# Community and Stakeholder Engagement Report

## Catherine Park, Scotland Island – Landscape Improvements Plan (Stage 2)

Consultation period: 12 September to 13 October 2024

This photo shows what Council is proposing – 1.5m coloured concrete like this recently constructed path through Catalpa Reserve. It will never merge into the landscape due to its size and colour.

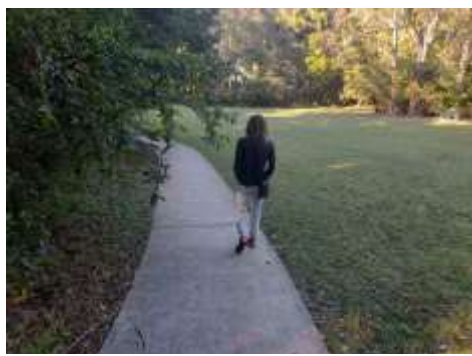
**Width of path – Please reduce width of path 2b) to 1.2m consistent with the crushed gravel path in 2a).**

This is wide enough for the actual usage and will fit better into the landscape. I have been told Council now makes paths a standard 1.5m to accommodate multi-use by bikes, prams, wheelchairs, mobility scooters, mobility walkers as well as pedestrians. However, this path is just used by pedestrians as all these other types of transport couldn't negotiate the many steps, steep slopes and dirt roads of the Island. If, once in a blue moon, any of these
